Herefordshire Local Plan

Hereford Area Plan

Housing and Employment Site Options Consultation

Technical Site Assessments - North East Hereford

Bur10

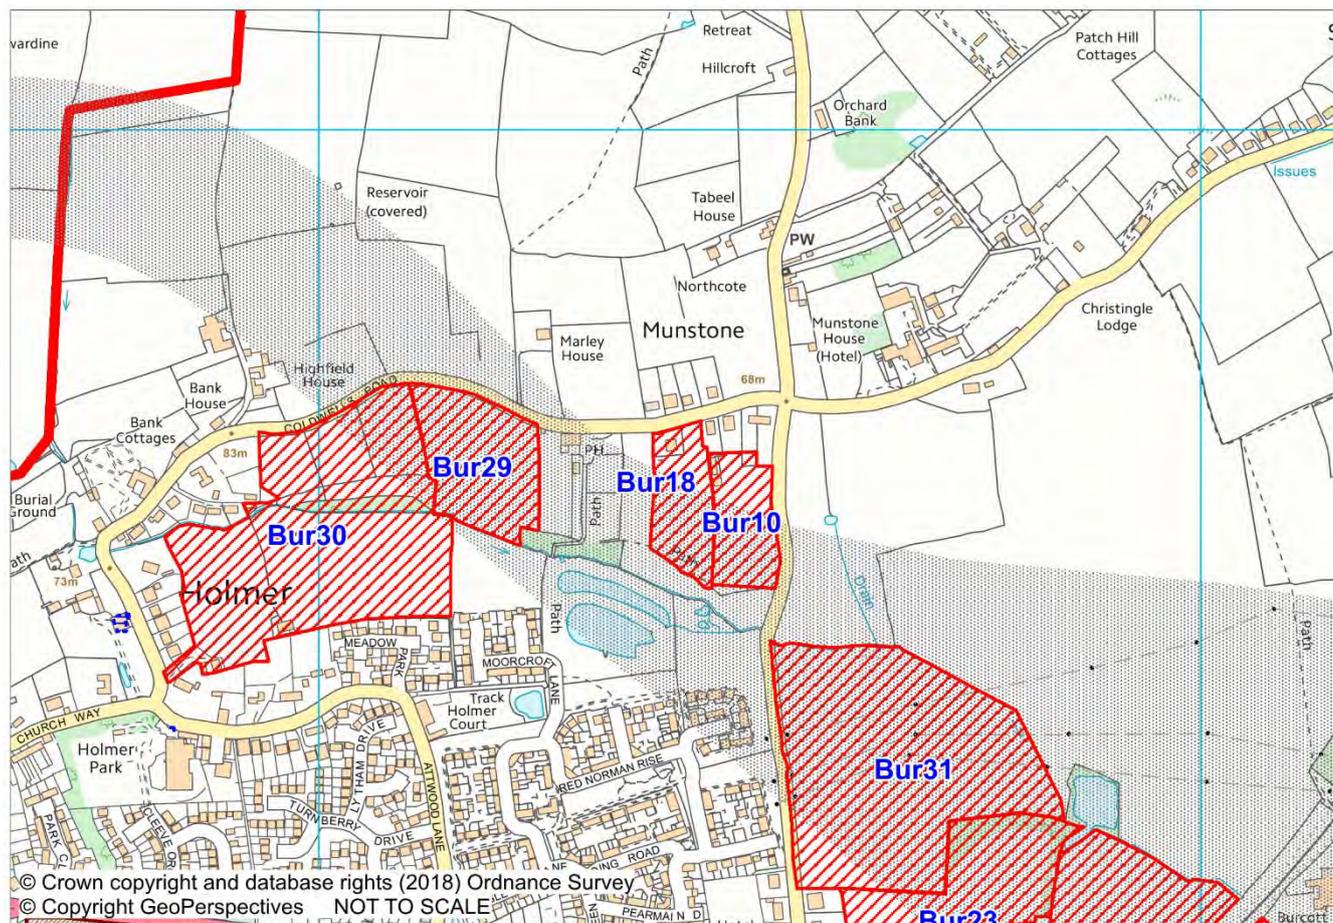
HC Highways comments
Public Transport accessibility comments
Are standards for access to local services likely to be achievable? No as the site is some way from bus stops/facilities and depends what links are delivered.
Access comments
Munstone Road would be inadequate to serve these developments without improvement and if achievable such improvements would require third party land. Munstone Road would be likely to need improvement to the Roman Road junction with footway provision and cycle footway links from the Bur10 site to the Crest site and possibly direct to Roman Road as well. The junction of Munstone Road/A4103 Roman Road/College Road is likely to need review as to layout and capacity for the increased traffic and pedestrian movements.
Local network comments
Any capacity concerns on this section of the network? Capacity of roads and junctions to the city centre would need to be reviewed as would the signalised railway bridge to the east. Railway bridge on College Road will be signalised as part of Holmer Trading Estate development. A Transport Assessment would be required to assess the impact of the development on the network, and as with all HAP sites the scope and developments to be considered will need to be confirmed.

Site dependence on Hereford Transport Package
Site falls within the north to east relief road corridor and it is unknown at this stage what the road layout will be in this area. An overall assessment of the acceptability with regard to highway network capacity will need to be carried out (once all sites are reviewed and shortlisted) to assess the cumulative impact and at which stage of the HTP those developments can be brought forward.
Mitigation measures
Suitable access. Widening of Munstone Road, pedestrian cycle links to Crest site and to Roman Road. Junction improvement A4103/Munstone Road
Highway Support
Not unless all access and connectivity issues are resolved and capacity exists for the development.
HC Landscape comments
Situated in final phase of road corridor. A landscape assessment should be carried out after the road alignment has been identified to determine the landscape capacity of the site.

HC Conservation comments
Built conservation
No known built heritage constraints
Archaeology
Likely to be suitable subject to acceptable assessment under NPPF Para 128. This comparatively small site does not appear to have been subject to much in the way of invasive agriculture, so may possibly retain some potential for

archaeological finds of interest. Currently, there are no real records relating to the site, and issues of substance are not anticipated.	
Biodiversity/Ecology	
HRA – River Wye SAC/SSSI	
All foul water should be managed through connection to main sewer network. Confirmation that this is possible and also acceptable to Welsh Water is necessary. No direct discharge of any foul water outfall from any onsite treatment system in to any watercourse or culvert will be considered acceptable. All surface water will need to be managed on site through a Sustainable Drainage system (SuDS).	
Protected Species (in line with NPPF, NERC Act, Core Strategy LD1-3)	
ANY demolition of existing building or structure or significant site clearance of vegetation will trigger a requirement for an Ecological Survey.	
Open Space requirements	<i>No assessment necessary at present</i>
Development Management	
<i>See conclusion below</i>

Conclusion			
The site is situated in the final phase of the road corridor (Core Strategy Figure 4.2). No route alignment work has been carried out on this section of the road as the Hereford Transport Package work currently focuses on the route section going from the A49 south of the city to the A49 north of the city. Identification of a route for the final phase is not expected until much later in the Plan period (up to 2031). It would be premature to provide an assessment of site potential where a road route is expected to be accommodated beforehand. Therefore, for the purposes of the Hereford Area Plan, this site is not considered to have development opportunity as a housing site.			
Evidence of site availability	No	Information source	HELAA 2015
Suitable for employment land	No

Bur12

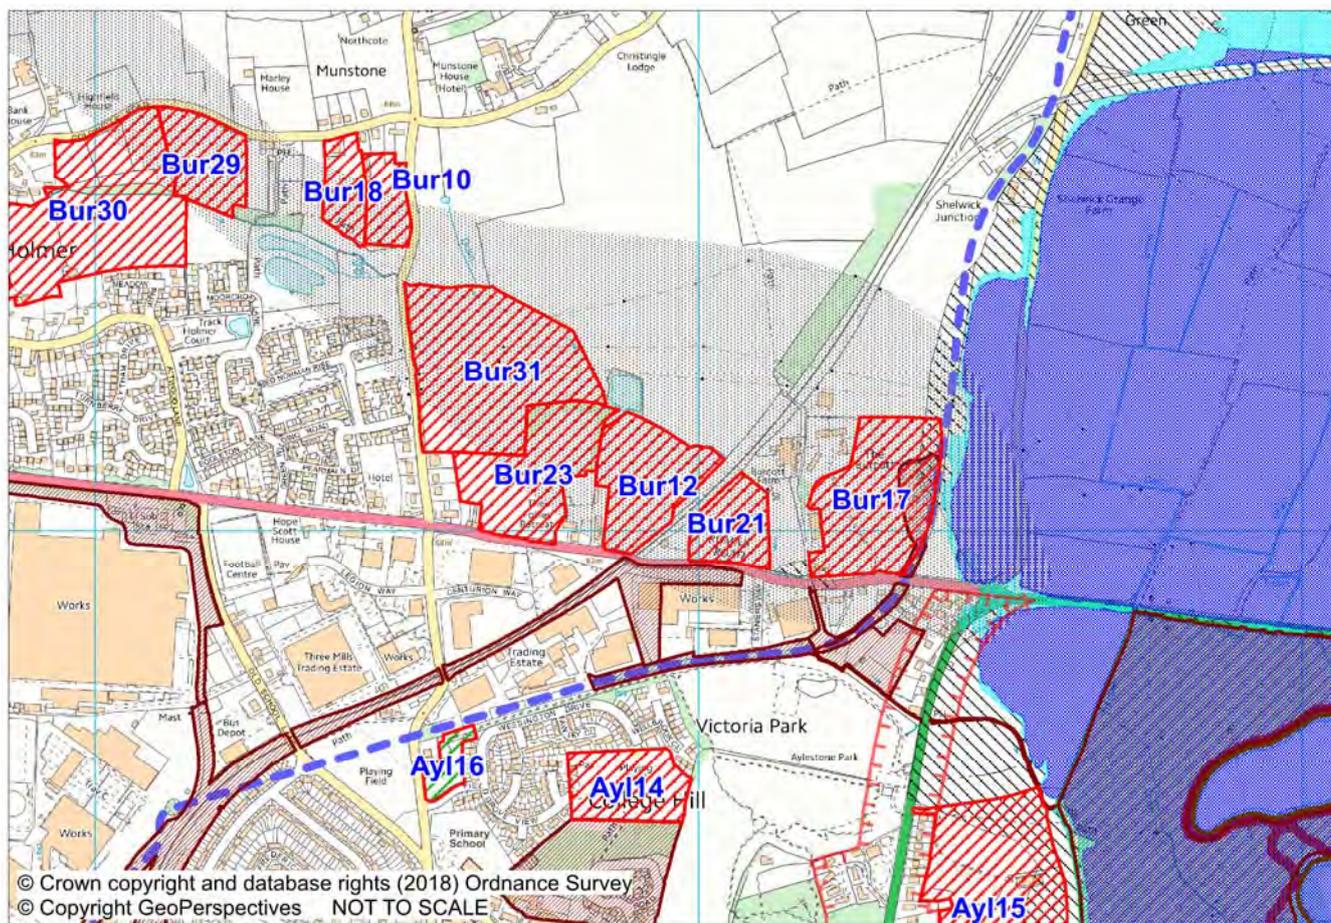
HC Highways comments
Public Transport accessibility comments
<i>Are standards for access to local services likely to be achievable?</i> No. Lack of footways along A4103 Roman Road in either direction will not render the site accessible on foot or give connectivity to local facilities and bus stops, and there is not sufficient highway land available to provide any. There is a cluster of proposed HAP sites in this area, and should they come forward together, as there may be other options for connectivity and access.
Access comments
An access from A4103 within the narrow frontage and this close to the signalised railway bridge would not be acceptable. Possible consideration of access through adjacent site Bur 23 if that site is deemed acceptable?
Local network comments
<i>Any capacity concerns on this section of the network?</i> There are capacity concerns throughout the network and the railway bridge just to the east of the site is a significant restraint. A49/A4103 junction to the west also has capacity issues as evidenced by the Holmer West SUE Transport Assessment. Aylestone Hill to the east and into the city centre suffers from queuing at peak hours and the impact of the new city link road does not appear to have reduced this. This would need to be covered in a Transport Assessment/Statement comparing vehicle movements and as with all HAP sites the scope and developments to be considered will need to be confirmed.

Site dependence on Hereford Transport Package
The site falls within the corridor for the final section of HRR (A49 to A4103(E)) and therefore until such time as a line is finalised, or it is decided not to pursue that section, development could prejudice the delivery of that section of the road. An overall assessment of the acceptability with regard to highway network capacity will need to be carried out (once all sites are reviewed and shortlisted) to assess the cumulative impact and at which stage of the HTP those developments can be brought forward.
Mitigation measures
HTP may release additional capacity.
Highway site support
Due to the above concerns, not considered an acceptable standalone site.

HC Landscape comments
Situated in final phase of road corridor. A landscape assessment should be carried out after the road alignment has been identified to determine the landscape capacity of the site.

Historic England - Issues & Options Consultation 2017 comments: A4013 is a Roman Road, consider in heritage assessment.
--

Conclusion			
<p>The site abuts the railway line on its western boundary. There is housing to the south with the remaining land having a mixture of agriculture fields and woodland adjoining. It is also identified under the British Geological Survey GeoIndex (onshore) mapping as a site with sand and gravel reserves. Although a useful resource the Council would not seek to quarry so close to an urban environment.</p> <p>The site is situated in the final phase of the road corridor (Core Strategy Figure 4.2). No route alignment work has been carried out on this section of the road as the Hereford Transport Package work currently focuses on the route section going from the A49 south of the city to the A49 north of the city. Identification of a route for the final phase is not expected until much later in the Plan period (up to 2031). It would be premature to provide an assessment of site potential where a road route is expected to be accommodated beforehand. Therefore, for the purposes of the Hereford Area Plan, this site is not considered to have development opportunity as a housing site.</p>

Bur17

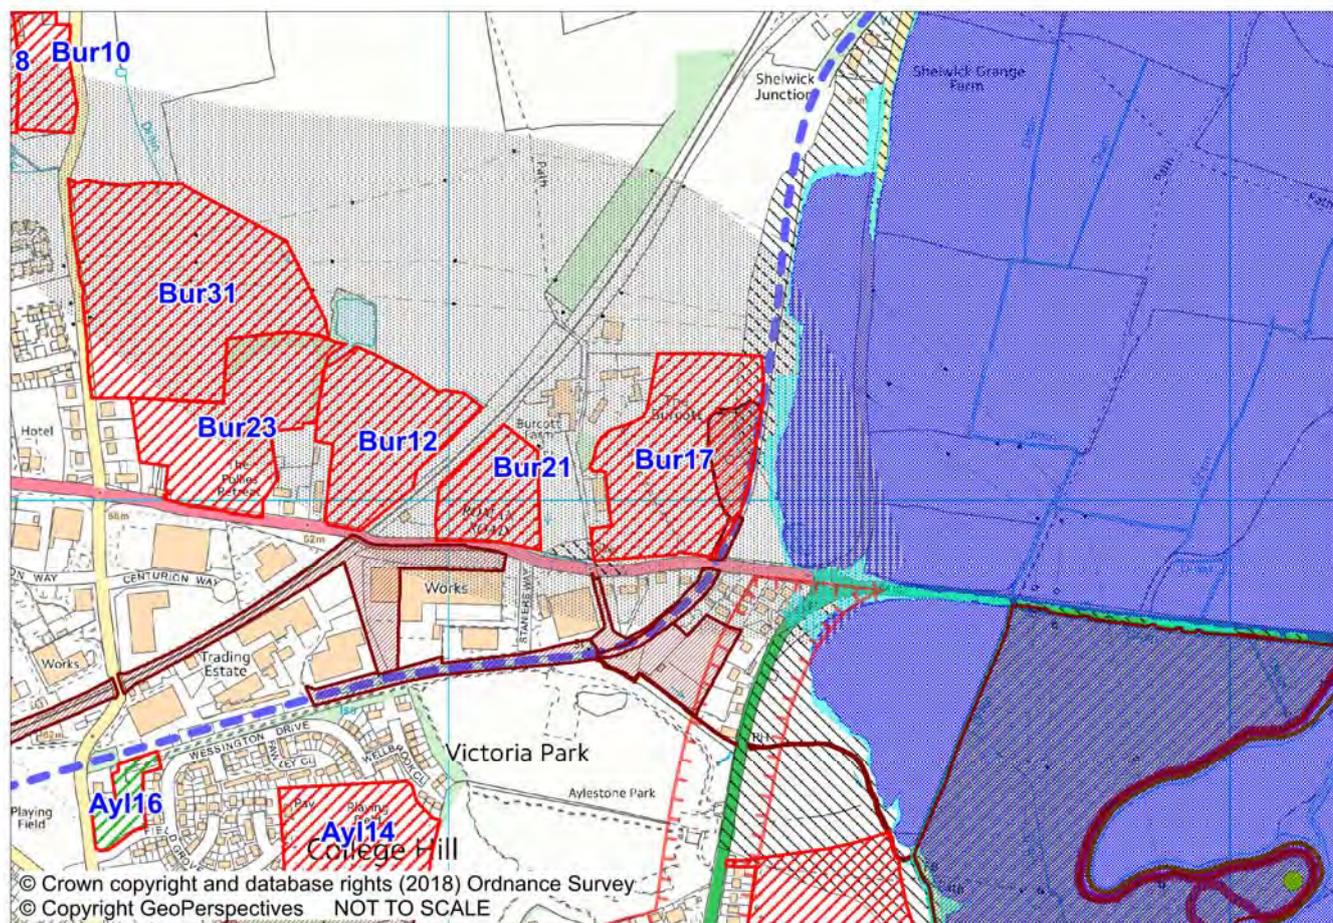
HC Highways comments
Public Transport accessibility comments
<p><i>Are standards for access to local services likely to be achievable?</i></p> <p>Bus services are available on Aylestone Hill, with footways on the southern side of A4103 from Staniers Way to Aylestone Hill for connectivity. There are however no footways to the west to the employment areas west of the railway line which does sever any pedestrian connectivity between the site and schools and other facilities to the west.</p>
Access comments
<p>A suitably designed access onto A4103 Roman Road would provide a suitable vehicular access but vertical alignment of the A4103 over the canal bridge and achievable visibility may be an issue. There is also a high pressure gas main parallel to A4103 along part of the frontage which may restrict access options. If Bur21 was brought forward as well, spacing of junctions may be a constraint. Pedestrian crossing points would need to be provided.</p>

Local network comments
<p><i>Any capacity concerns on this section of the network?</i></p> <p>Signalised railway bridge to the west is a constraint and suffers from queuing during peak hours and issues with Starting Gate roundabout further west. Aylestone Hill to the east and into the city centre suffers from queuing at peak hours and the impact of the new city link road appears to have exacerbated this.</p> <p>This would need to be covered in a Transport Assessment/Statement comparing vehicle movements and as with all HAP sites the scope and developments to be considered will need to be confirmed.</p>
Site dependence on Hereford Transport Package
<p>An overall assessment of the acceptability with regard to highway network capacity will need to be carried out (once all sites are reviewed and shortlisted) to assess the cumulative impact and at which stage of the HTP those developments can be brought forward.</p>

Mitigation measures
<p>Delivery of HTP to provide network capacity.</p>
Highway site support
<p>The site falls within the corridor for the final section of HRR (A49 to A4103(E)) and therefore until such time as a line is finalised, or it is decided not to pursue that section, development could prejudice the delivery of that section of the road.</p> <p>If the site did not impact the relief road, subject to network capacity at the time the site is brought forward, this could be considered an acceptable site for development.</p>
HC Landscape comments
<p>Situated in final phase of road corridor. A landscape assessment should be carried out after the road alignment has been identified to determine the landscape capacity of the site.</p>

HC Conservation comments
Built conservation
<i>Not assessed</i>
Archaeology
<i>Not assessed</i>
Biodiversity/Ecology
<i>Not assessed</i>
Open Space requirements
<i>No assessment necessary at present</i>
Development Management
Landscape will advise separately, but this site is rather more open and perhaps less influenced by the edge of urban development elsewhere along Roman Road. To this extent the site's appropriateness for development is unlikely.

Historic England
<i>Issues & Options Consultation 2017 comments: A4013 is a Roman Road, consider in heritage assessment.</i>

Conclusion			
<p>The site lies very much on the outer edge of the city with a small residential development to the north west of the sites. The protected route of the canal affects the eastern portion of the site and a Special Wildlife Site forms part of this; 'The Old Canal at Burcott'.</p> <p>The site is identified under the British Geological Survey GeoIndex (onshore) mapping as a site with sand and gravel reserves. Although a useful resource, the Council would not seek to quarry so close to an urban environment.</p> <p>The site is situated in the final phase of the road corridor (Core Strategy Figure 4.2). No route alignment work has been carried out on this section of the road as the Hereford Transport Package work currently focuses on the route section going from the A49 south of the city to the A49 north of the city. Identification of a route for the final phase is not expected until much later in the Plan period (up to 2031). It would be premature to provide an assessment of site potential where a road route is expected to be accommodated beforehand. Therefore, for the purposes of the Hereford Area Plan, this site is not considered to have development opportunity as a housing site.</p>

Bur18

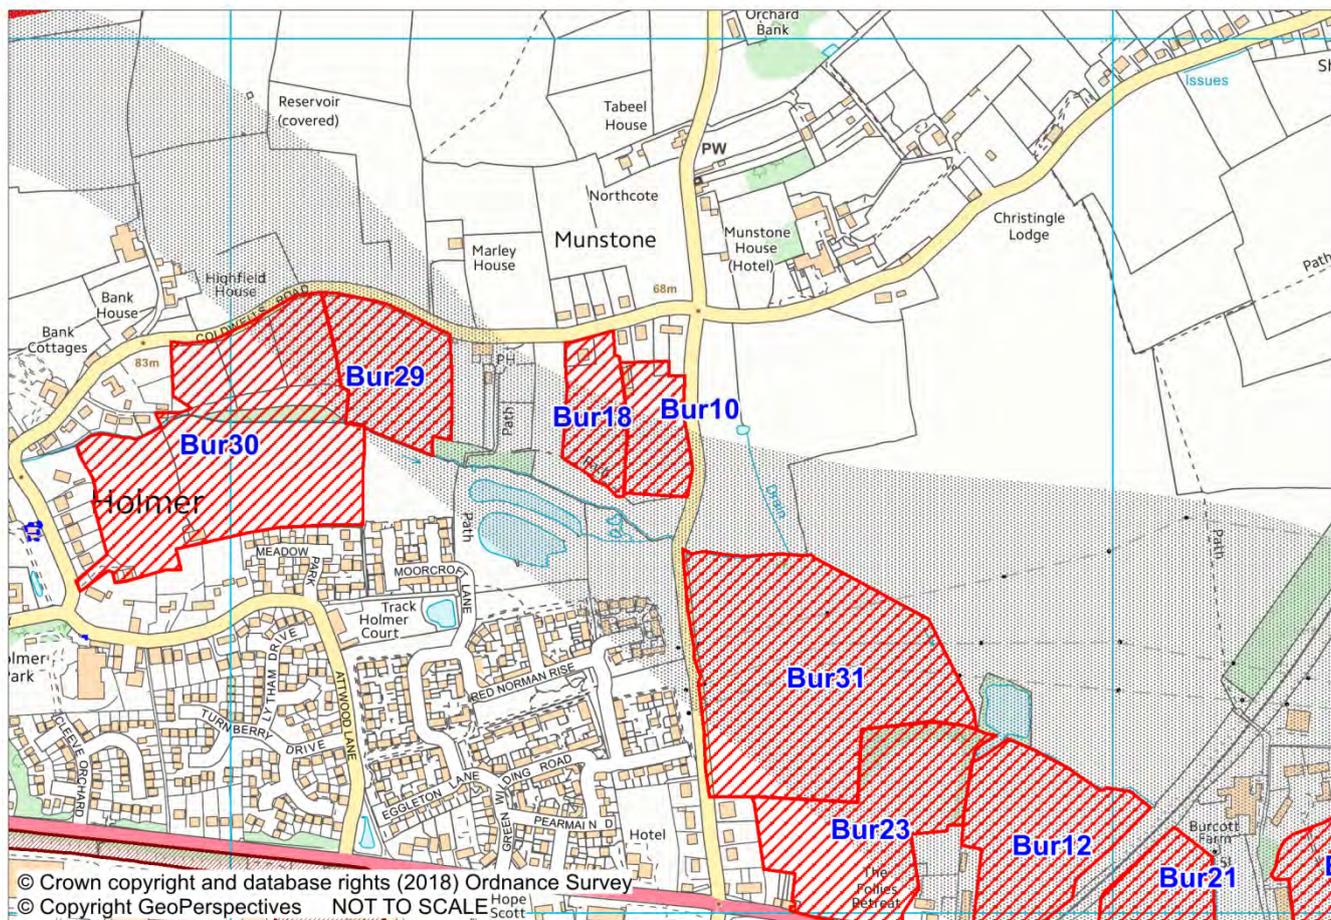
HC Highways comments
Public Transport accessibility comments
<i>Are standards for access to local services likely to be achievable?</i> Not ideal, some way from bus stops/facilities and depends what links are delivered.
Access comments
Munstone Road And Coldwells Road in particular would be inadequate to serve these developments without improvement, and if achievable such improvements would require third party land. Any access would need to be from Munstone Road, with Bur18 accessing through Bur10, and Munstone Road would be likely to need improvement to the Roman Road junction with footway provision and cycle footway links to the Crest site and possibly direct to Roman Road as well. That junction itself may need review as to layout and capacity for the increased traffic and pedestrian movements. Capacity of roads and junctions to the city centre would need to be reviewed as would the signalised railway bridge on A4103 to the east. A Transport Assessment would be required to assess the impact of the development on the network, and as with all HAP sites the scope and developments to be considered will need to be confirmed.

Local network comments
<i>Any capacity concerns on this section of the network?</i> Capacity of roads and junctions to the city centre would need to be reviewed as would the signalised railway bridge to the east. Railway bridge on College Road will be signalised as part of Holmer Trading Estate development. A Transport Assessment would be required to assess the impact of the development on the network, and as with all HAP sites the scope and developments to be considered will need to be confirmed.
Site dependence on Hereford Transport Package
Site falls within the north to east relief road corridor and it is unknown at this stage what the road layout will be in this area. An overall assessment of the acceptability with regard to highway network capacity will need to be carried out (once all sites are reviewed and shortlisted) to assess the cumulative impact and at which stage of the HTP those developments can be brought forward.

Mitigation measures
Suitable access. Widening of Munstone Road, pedestrian cycle links to Crest site and to Roman Road. Junction improvement A4103/Munstone Road.
Highway site support
Not unless all access and connectivity issues are resolved and capacity exists for the development.
HC Landscape comments
Situated in final phase of road corridor. A landscape assessment should be carried out after the road alignment has been identified to determine the landscape capacity of the site.
HC Conservation comments
Built conservation

No known built heritage constraints.
Archaeology
Likely to be suitable, subject to acceptable assessment under NPPF Para 128. This comparatively small site does not appear to have been subject to much in the way of invasive agriculture, so may possibly retain some potential for archaeological finds of interest. Currently, there are no real records relating to the site, and issues of substance are not anticipated.
Biodiversity/Ecology
HRA – River Wye SAC/SSSI All foul water should be managed through connection to main sewer network. Confirmation that this is possible and also acceptable to Welsh Water is necessary. No direct discharge of any foul water outfall from any onsite treatment system in to any watercourse or culvert will be considered acceptable. All surface water will need to be managed on site through a Sustainable Drainage system (SuDS). Protected Species (in line with NPPF, NERC Act, Core Strategy LD1-3) Any demolition of existing building or structure or significant site clearance of vegetation will trigger a requirement for an Ecological Survey.

Conclusion			
The site is situated next to a small group of houses to the north and the remainder is agricultural land. The site is separated from the main urban area by fields to the south.			
The site is situated in the final phase of the road corridor (Core Strategy Figure 4.2). No route alignment work has been carried out on this section of the road as the Hereford Transport Package work currently focuses on the route section going from the A49 south of the city to the A49 north of the city. Identification of a route for the final phase is not expected until much later in the Plan period (up to 2031). It would be premature to provide an assessment of site potential where a road route is expected to be accommodated beforehand. Therefore, for the purposes of the Hereford Area Plan, this site is not considered to have development opportunity as a housing site.			
Evidence of site availability	No	Information source	HELAA 2015
